**Service Bulletin RU_SB024**

Author: Alexander Gaiderov, Technical Support
Date: 2004-02-03
Subject: GSM Triplets – Antenna Issue
Rating: Level 3 Authorized

Products: V300, V500, V525

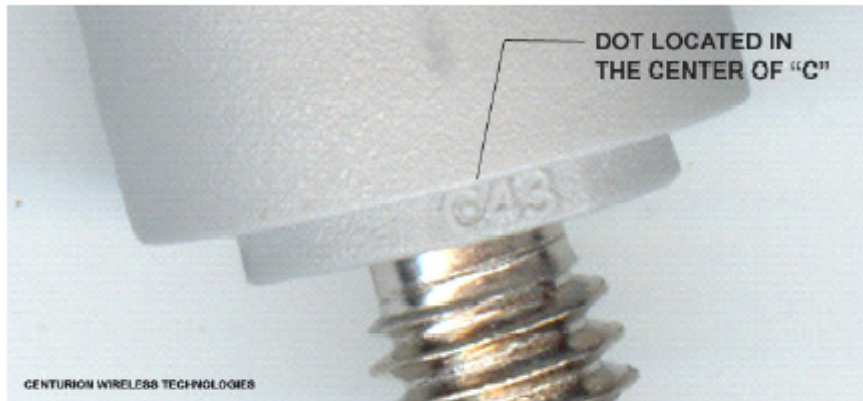
The effect of the loss in TRP may cause the user to have trouble placing / receiving calls or calls may be dropped. In addition, the loss in TRP can decrease the "Talk-Time" battery performance. The Root Cause of this issue was determined to be an antenna assembly issue at Centurion. The tang of the meander is not properly in place before the connector is mounted. This causes an intermittent electrical condition that occurs when the antenna is torqued onto the phone. *Note: The antenna can not be visually inspected for this defect.*

Figure 1.0 – Identification of New and Screened Parts

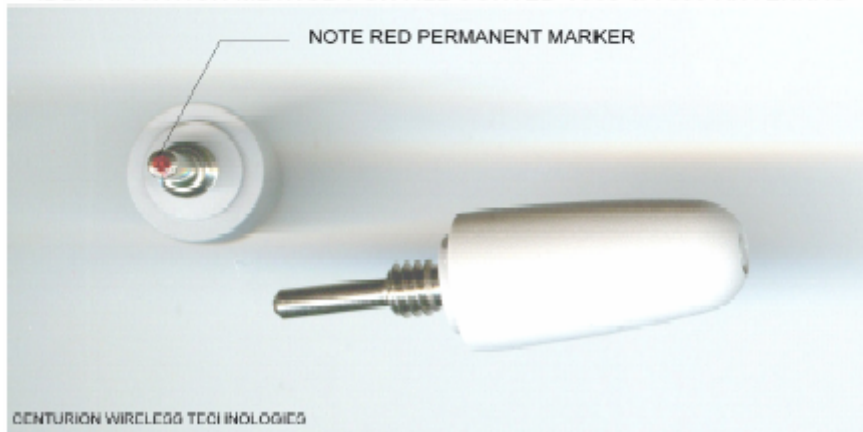
Solution: Automated fixtures have been implemented by Centurion to replace manual bending of the tang. A screening process, which includes a screening fixture to over-torque antenna, has been defined and implemented by the Quality team at Centurion in place to both fix production and identify means for sorting existing in house material. Centurion has replaced inventories with antennas processed after Nov.20th when all process improvements and screening was in place. New parts, built after Nov.20th, are uniquely marked with a "Dot" inside the "C" at base of plastic. Screened parts will be marked with a "Red Dot" at the metal tip. See Figure 1.0 below.

**IDENTIFICATION METHOD FOR ALL V300 & V500
ANTENNAS MANUFACTURED STARTING NOVEMBER 20th.**

IDENTIFICATION METHOD FOR ALL SORTED V300 & V500 ANTENNAS

Please quarantine all existing stock of the 8588912N01 V300 and 8589122N01 V500/V525 antenna and replace with new parts built after November 20, 2003.

See Figure 1.0 for identification markings on new parts.
